# CITY OF ALBUQUERQUE

**RE: Academy Parkway Self-Storage  
3605 Osuna Rd. NW  
Grading and Drainage Plan  
Engineer's Stamp Date: 08/05/19  
Hydrology File: E17D001W**

Based upon the information provided in your submittal received 08/06/2019, the Grading & Drainage Plan **is not** approved for Building Permit. The following comments need to be addressed for approval of the above referenced project:

C-2

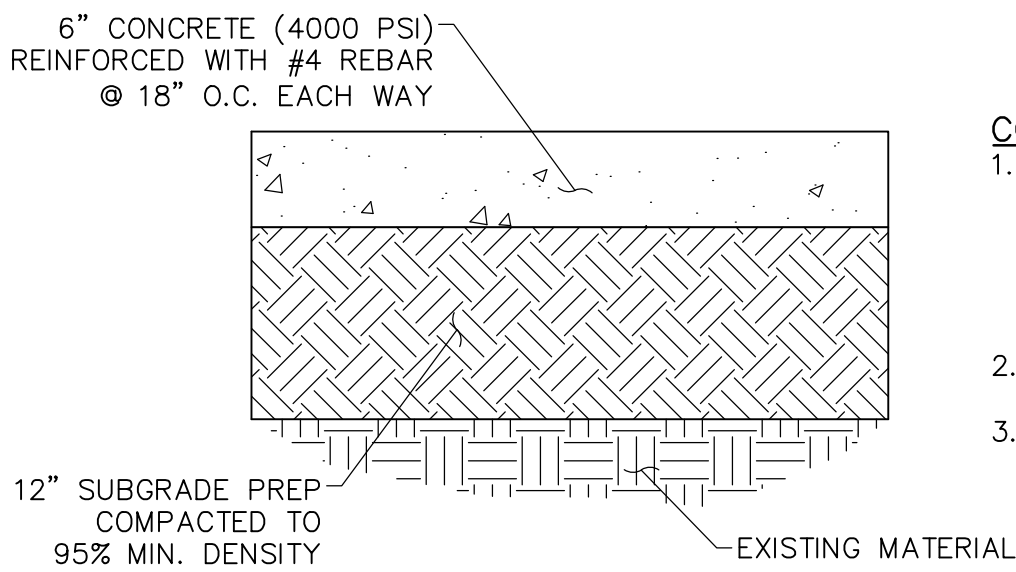
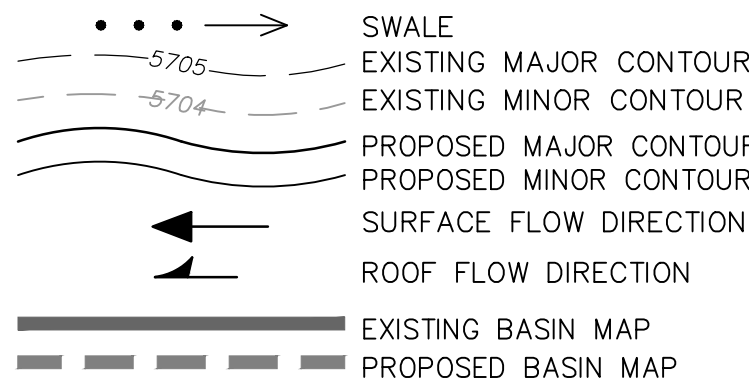
1. Since this project is adjacent to, or drains into an Albuquerque Metropolitan Arroyo and Flood Control Authority (AMAFCA) facility, approval by AMAFCA will be need prior to Hydrology approval. Please contact Nicole Friedt P.E, CFM ([nfriedt@amafca.org](mailto:nfriedt@amafca.org) or 505-884-2215).
2. Please show the Floodplain Zone "A" within the AMAFCA's North Diversion Channel on both sheets.
3. Please label AMAFCA's North Diversion Channel on both sheets.
4. Sheet C-1. Please show the stormwater quality ponds per AMAFCA's email dated 8/19/19.
5. Sheet C-1. Please remove the SO-19 Notes and replace with a note stating, "Coordinate with AMAFCA at (505) xxx-xxxx 48 hours prior to work within AMAFCA's North Diversion Channel." Please contact Nicole at AMAFCA for the contact person and number.
6. Sheet C-2. Please label "Academy Parkway S. NE" on both Basin Maps.

7. Sheet C-2 under Proposed Conditions. Since AMFCA is requiring the stormwater quality ponds please remove the line "The Owner will pay fee in lieu instead of retaining the first flush volume".

8. Sheet C-2 Proposed Basin Map. Please show the stormwater quality ponds per AMAFCA's email dated 8/19/19.
9. As a reminder, if the project total area of disturbance (including the staging area and any work within the adjacent Right-of-Way) is 1 acre or more, then an Erosion and Sediment Control (ESC) Plan and Owner's certified Notice of Intent (NOI) is required to be submitted to the Stormwater Quality Engineer (Dough Hughes, PE, [jhughes@cabq.gov](mailto:jhughes@cabq.gov), 924-3420) 14 days prior to any earth disturbance.
